TMS320DM355/DM335 Migration Guide (silicon revision 1.1, 1.3 and 1.4)

ABSTRACT

This application report describes the differences between Silicon revision 1.1, 1.3 and 1.4 of the TMS320DM355/DM335 digital media system-on-chip (DMSoC). This document discusses behavior different from that described in the *TMS320DM355 Digital Media System-on-Chip (DMSoC) ARM Subsystem User's Guide* ([SPRUFB3](#)) and the *TMS320DM335 Digital Media System-on-Chip (DMSoC) ARM Subsystem User's Guide* ([SPRUFX7](#)).

Figure 1. NAND Boot Process in Silicon Revision 1.4

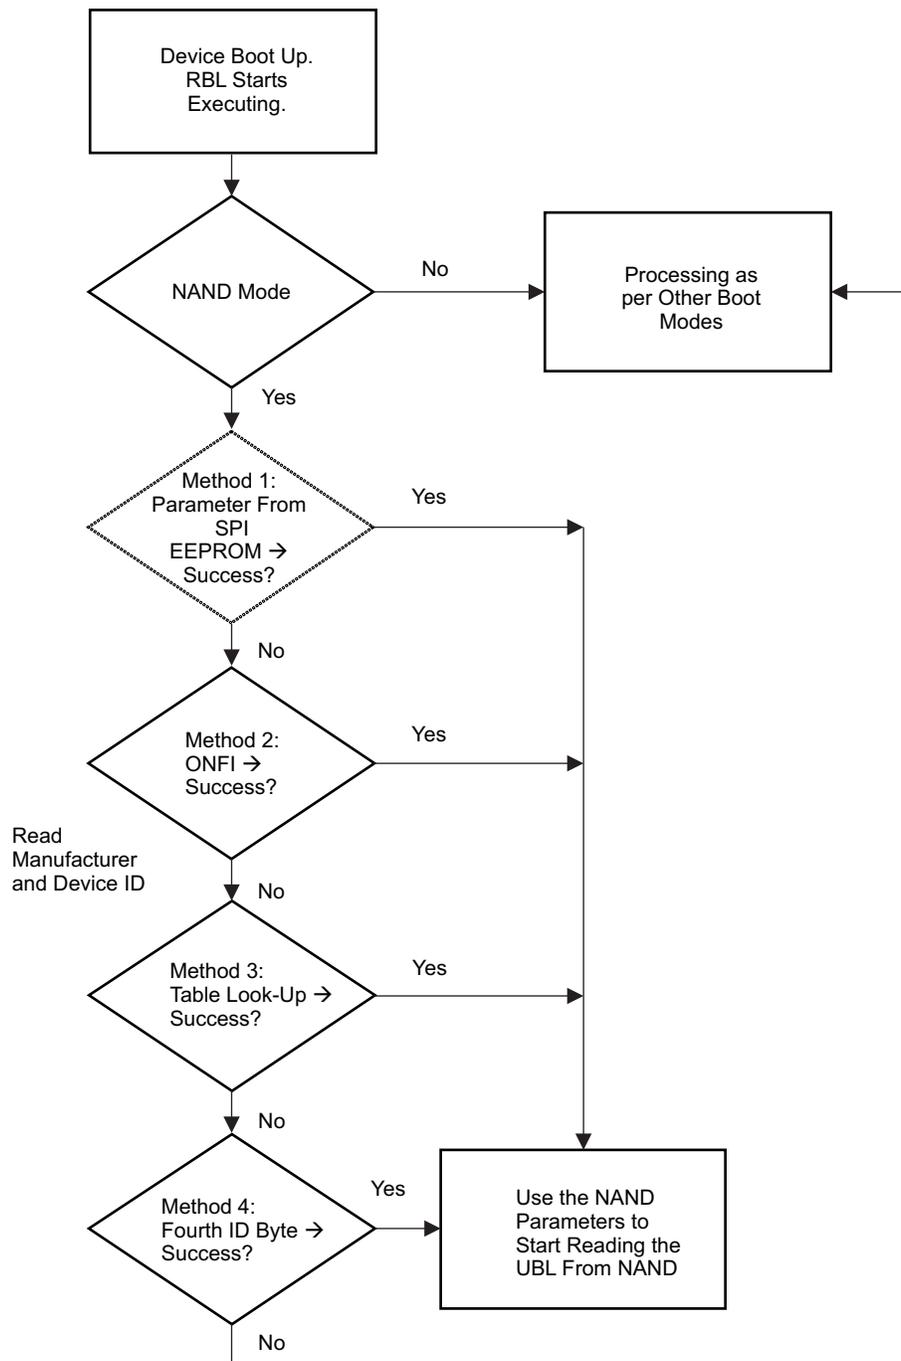
The silicon revision 1.4 adds new methods to detect NAND parameters apart from the existing 4th ID byte information and device table. These are:

The NAND-boot mode code flow in silicon revision 1.4 is illustrated in Figure 1.

To provide serial boot support, SPI boot support has been added. Due to the limitation of boot pins, the SPI-boot mode has been added as a part of NAND boot. If an EEPROM is detected with a pre-defined magic pattern during NAND boot, it indicates SPI boot. In this scenario, SPI boot is performed. The header format for SPI boot is defined in [Table 6](#).
